ADDENDUM NO. 02

CLOVIS COMMUNITY COLLEGE SPORTS COMPLEX
Fresno, CA 93730
2425-22

DARDEN PROJECT NO. 2175
DSA File Nos. 10-C3
DSA APPL. NO. 02-122242

The following additions, deletions, and revisions to the SHEETS and Project Manual are hereby made and do become a part of these Contract Documents.

AD02-TX02

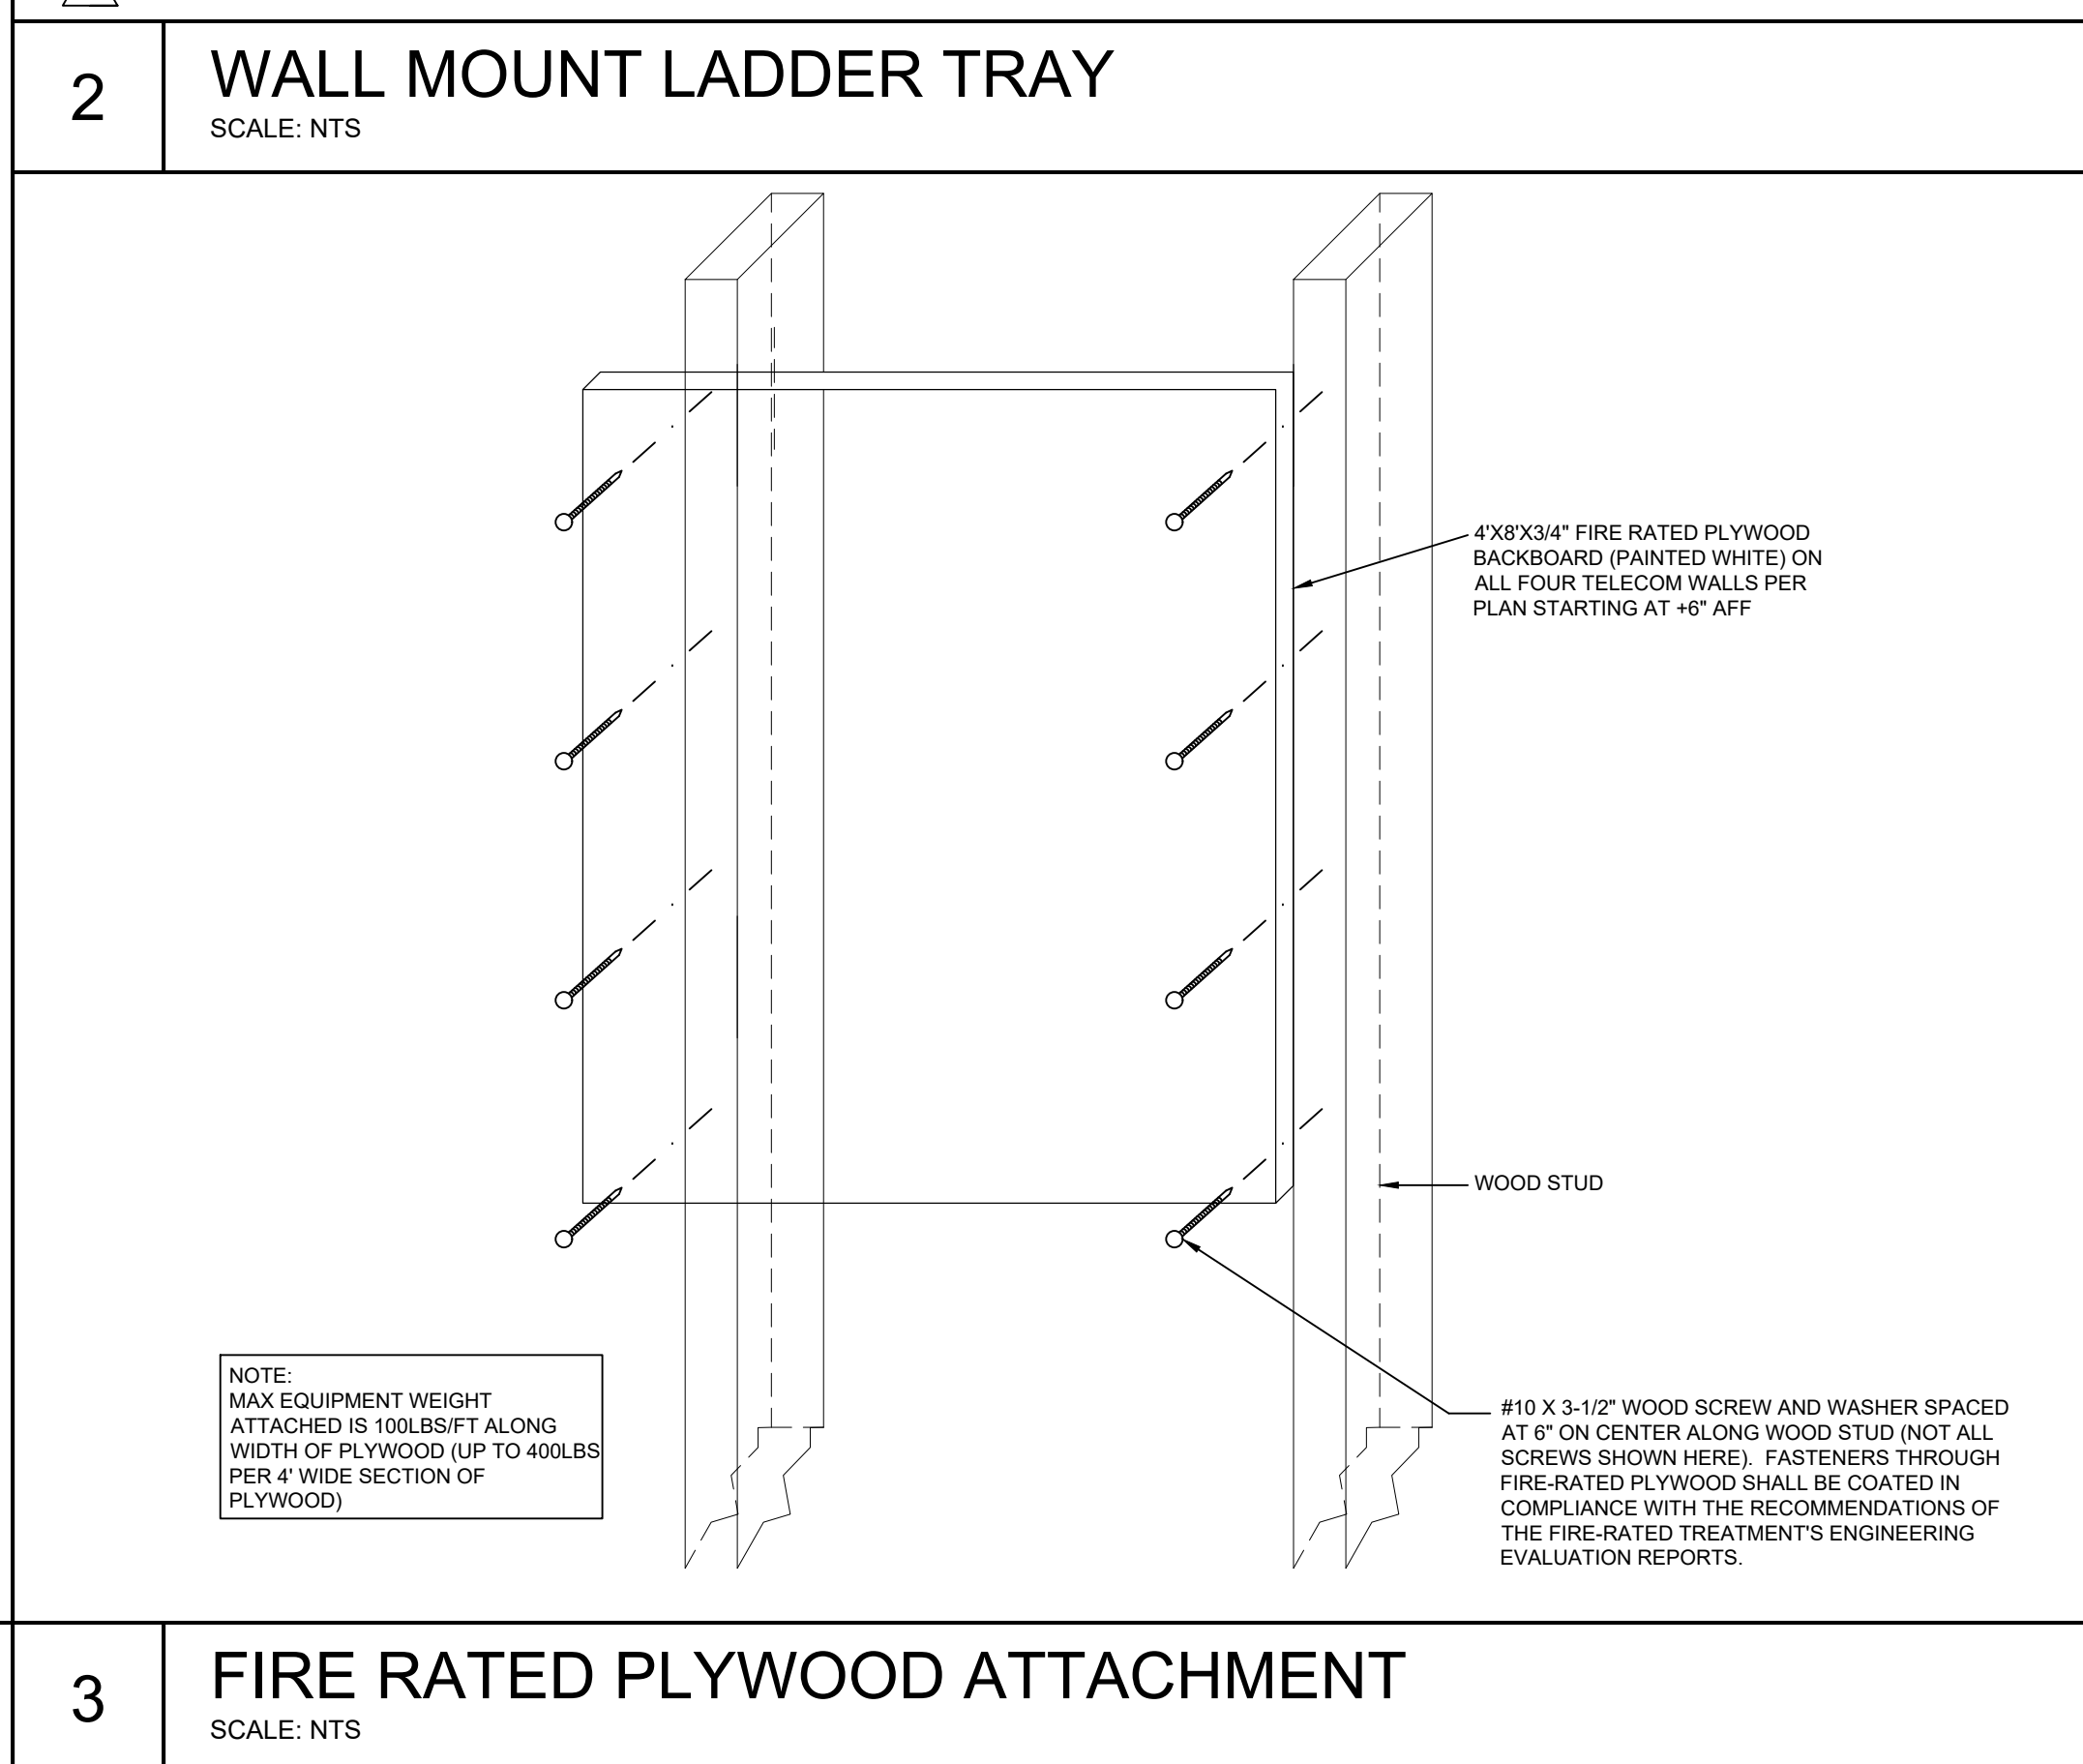
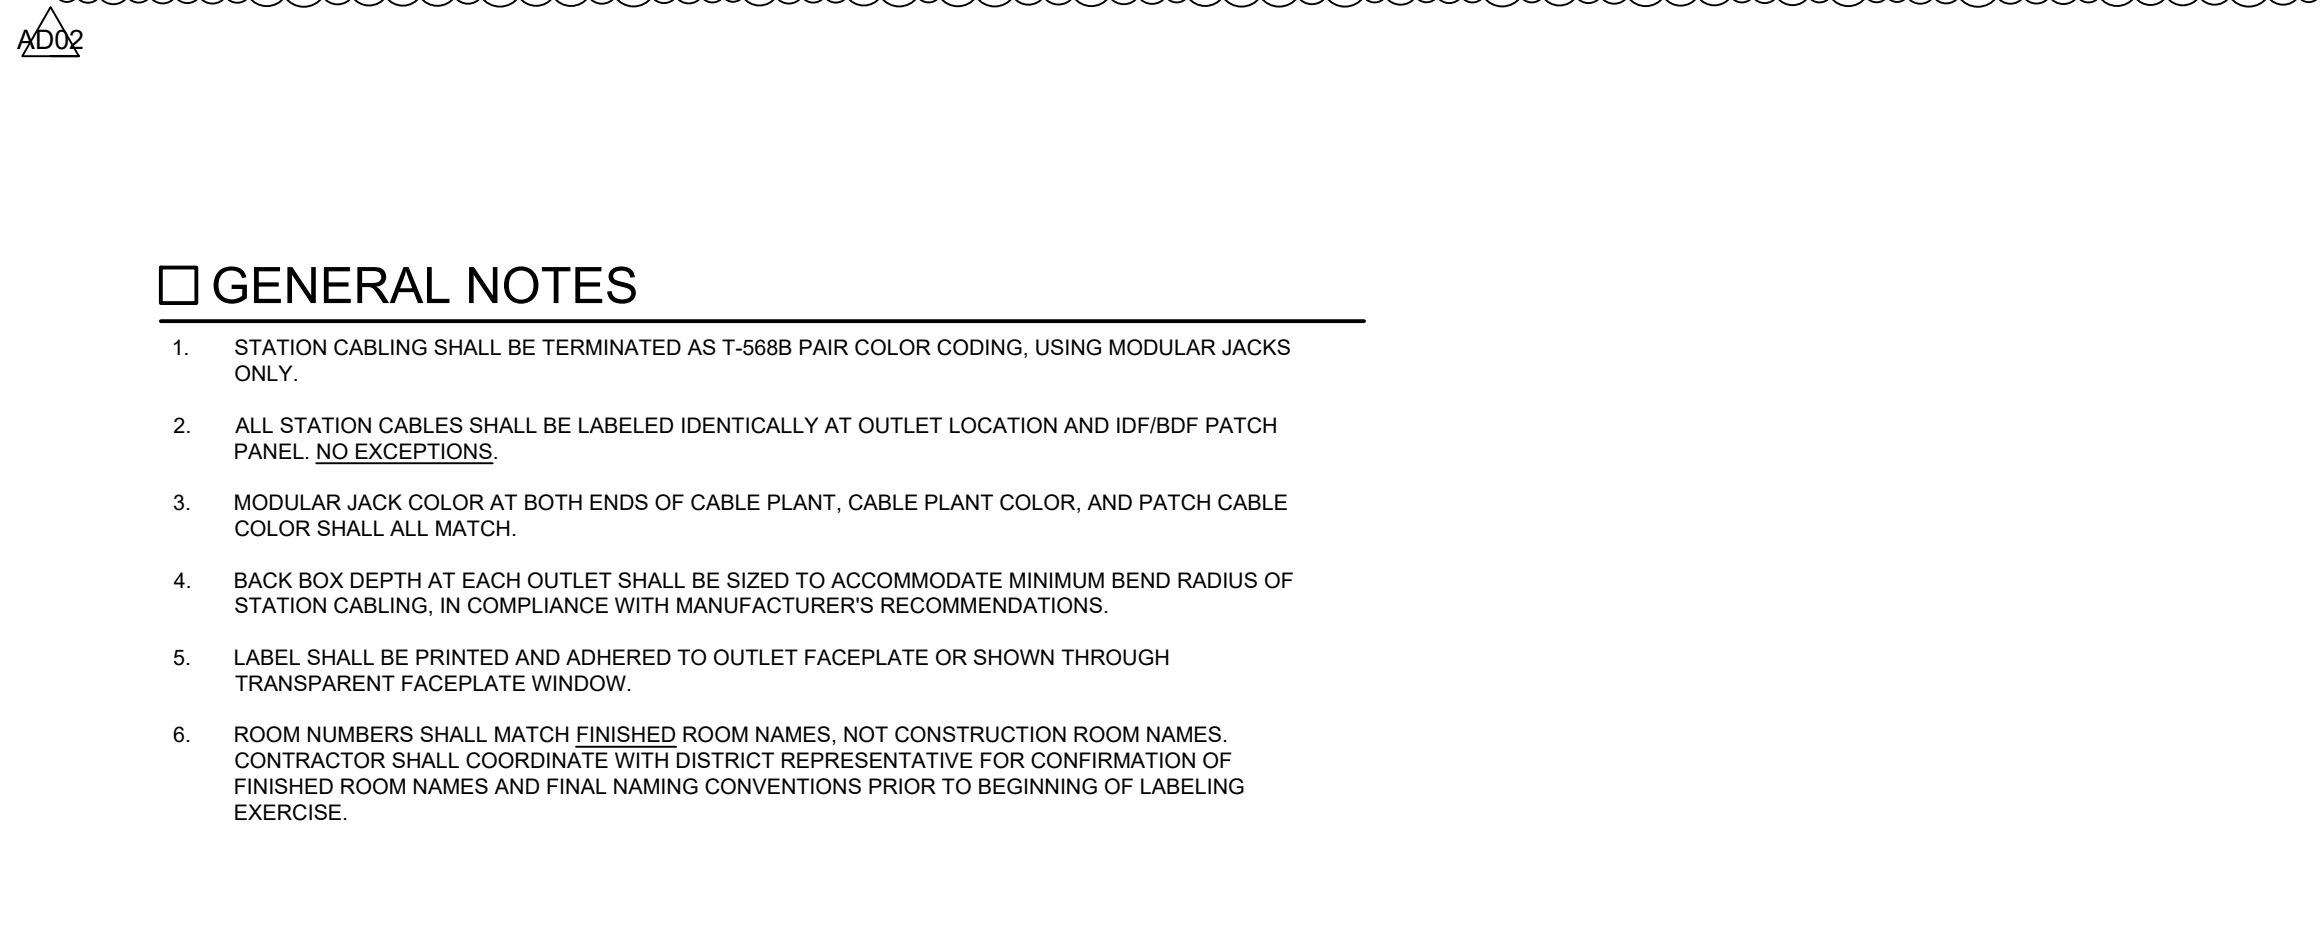
AD02-T02 Refer to Sheet X/T201, and attached drawing AD02-TX02:

1. Refer to Riser Diagram General Notes. Remove notes 3 & 4 regarding patch cords and cables.
2. Refer to Cabling Schedule. Revise CAT6A cable part number.

3. Refer to Cabling Schedule. Delete OSP25, CAT3 Telephone Cable.
4. Refer to Riser Diagram. Delete OSP25, CAT3 Telephone Cable and associated 110 Terminal Block shown between Bldg. 11 MDF and Sport Center Bldg. BDF.

5. Refer to Riser Diagram. Add Service Loops fiber optic cables.
6. Refer to Riser Diagram. Remove "By Others" note from graphic symbol of UPS's.
7. Refer to Riser Diagram. Revise Bldg. 11 Data Room designation from Data 113T to AC1-133.

8. Refer to Riser Diagram. Add (3) wall phone outlets. Add IP speakers. Add a data outlet at Future Musco Equipment.
9. Refer to Riser Diagram. Revise the fiber optic cable shown between Sport Center Bldg. BDF and Press Box remote IDF from cable type SM12 to SM24.

10. Refer to Riser Diagram Reference Notes. Modified note 4 and added notes 14 and 15 to plans.
11. Refer to Riser Diagram. Added exterior WAPs at Pressbox and modified cable counts accordingly.

12. Refer to Riser Diagram. Modified conduit/cable routing between Pressbox and remote IDF.
